CHAPTER 6 DUCT SYSTEMS

IMC Interpretation No. 09-03
Section 606.2.1, 2000 Edition
Issued: 05-21-03

Attachment Drawing # 1

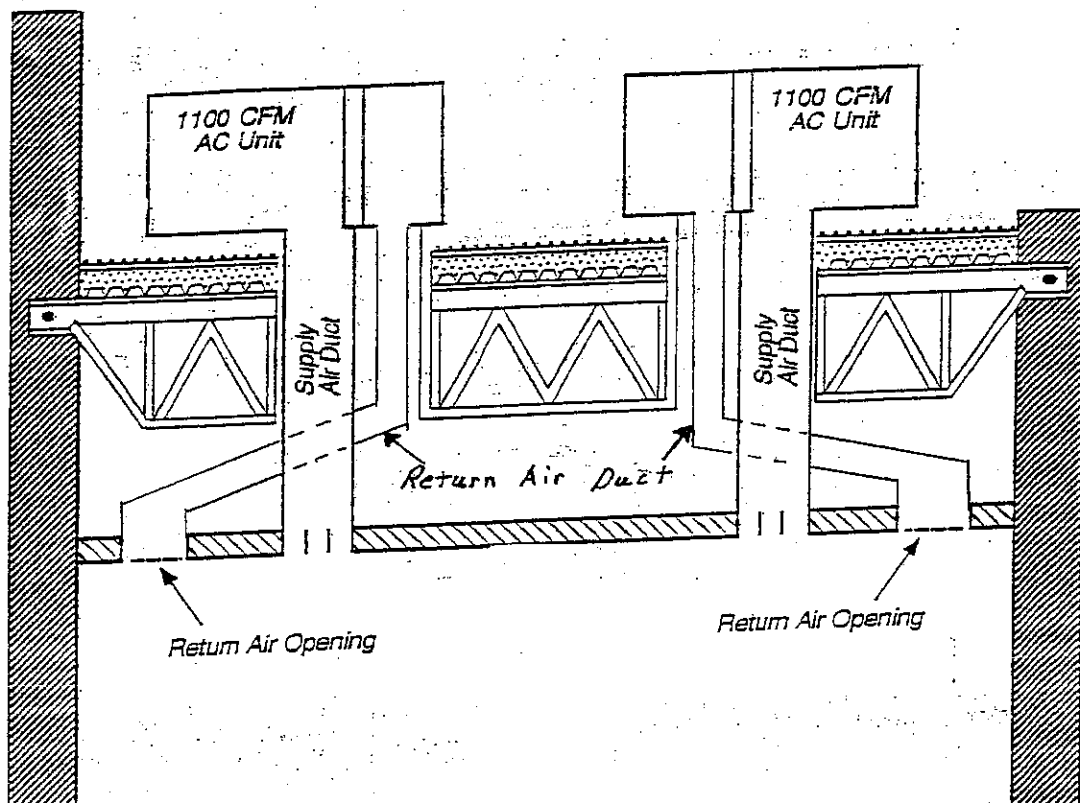
Q: The attached drawing shows two air-conditioning units with a design capacity of 1100 cfm each with a separate return air system for each unit. The two air conditioning units serve a common area. Section 606.2.1 of the 2000 *International Mechanical Code* requires a smoke detector in return air systems with a design capacity greater than 2000 cfm.

Are smoke detectors required in the return air ducts or plenums where the supply air and the return air are ducted separately to each air conditioning unit?
 See Attachment Drawing # 1.

A: No. Smoke detectors are not required in the return air ducts per the attached drawing. The capacity of the two air conditioning units is only added together when the units share a common supply duct, return air duct or plenum.
